COMMENTS & RESPONSES TABLE

NAME & DATE	COMMENT	RESPONSE
COMMENTS RECEIVED ON NOTIFICATION		
Pre-App Meeting Minutes 19.09.2023	Pre-Application Meeting Minutes Project: Umdoni South Bulk Water Augmentation Location: Virtual Meeting – Whatsapp Conference Call Date: 9:45 on the 19th of September 2023 Attendees: EnviroPro – Dustin Bell (DB) EnviroPro – Oliver Chater (OC) EDTEA – Melissa Packree (MP) EDTEA – Sinethemba Mbambo (SM) An initial virtual Pre-Application Meeting was held to discuss the Environmental Authorization (EA) requirements for the Umdoni South Bulk Water Augmentation project (Part 1: virtual meeting). The following is a summary of points raised at the pre-application meeting. The following documents were submitted before the meeting: locality map, draft application form, pre-app meeting agenda, and DFFE Screening Report. PART 1: VIRTUAL MEETING Project description The Ugu District Municipality proposes to upgrade the secondary bulk pipeline and storage to align with the increased demand at the Umdoni command reservoir, which supplies the settlements of Sezela, Pennington, Umdoni Village, Kelso, Malangeni, Bazley, Ifafa, and Hilltop, located on the South Coast of KwaZ

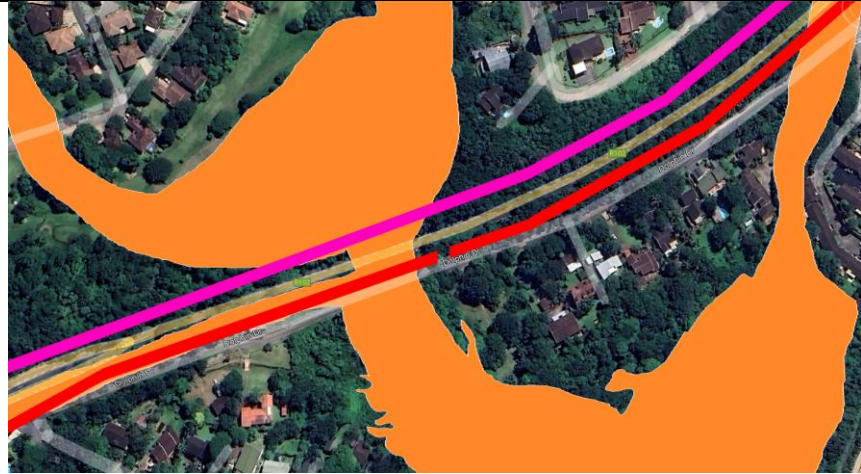
NAME & DATE	COMMENT	RESPONSE
	5. DBAR states that after consulting the desktop data and visiting the site, it was determined that there were no wetlands within the project area, only rivers, estuaries, and associated tributaries/drainage areas ... ❖ We disagree with the statement that no wetlands were found e.g. there is a significant hill-slope seep wetland associated with crossing WC1 - Further more we find the designation of micro-estuaries rather strange in areas as far inland as Ifafa Glebe and Amangamazi - local knowledge knows these as hill-slope seep wetlands and they must be augured to show their extent, especially where the pipeline will cross, and to ensure that the correct soil profile is known, understood and rehabilitated in terms of soil replacement and vegetation. 6. The DBAR states that there are small patches of Forest along the pipeline route that fall within existing road and pipeline servitudes. Trees within these Forests will require pruning or removal for the construction of the pipeline within the 10m construction corridor. The appropriate permits will be required prior to commencement of clearance for these areas. ❖ The removal of trees can in most cases, with a little care and planning be avoided. We request that this is avoided as much as possible and that the only pruning that MUST be done, is done by a tree felling specialist to avoid damaging the trees like splitting branches and tearing bark which leaves the tree in a susceptible condition to disease and die-back. All pruned branches must be sealed after cutting. It must be borne in mind that many of the forests referred to are climax forests, and are highly functional – albeit they are remnants	Please note after discussion with the specialist they have confirmed that the area near WC1 is not a wetland and remains a drainage area due to riparian features. As per the specialist feedback, Ifafa Glebe and Amangamazi areas are not designated as micro-estuaries. Due to the meandering nature (including alluvium) and riparian areas (presence of marginal trees), these have been characterised as drainage areas and will remain so. The micro-estuaries only occur at the coast and have been indicated in Figures 24 -28. In terms of the soil profile individual mitigations as per the specialist have been included to ensure soil profiles are maintained following rehabilitation: • Document the soil profile on removal and ensure the soil is backfilled in the same horizon order in which it was removed. Ensure that topsoil is appropriately stored and re-applied; and • Make sure that the soil is backfilled and compacted to appropriate geotechnical specifications for the project area. Please note that the EMPr only allows the clearance of vegetation that is necessary for the construction of the pipeline. The following mitigation has been included in the BAR and EMPr and will be legally binding: • The vegetation that will be cleared must be restricted to the construction footprint of the pipelines. No vegetation may be cleared other than that is required for access to the site or for the construction activities associated with the construction of the Umdoni Water Supply Infrastructure.
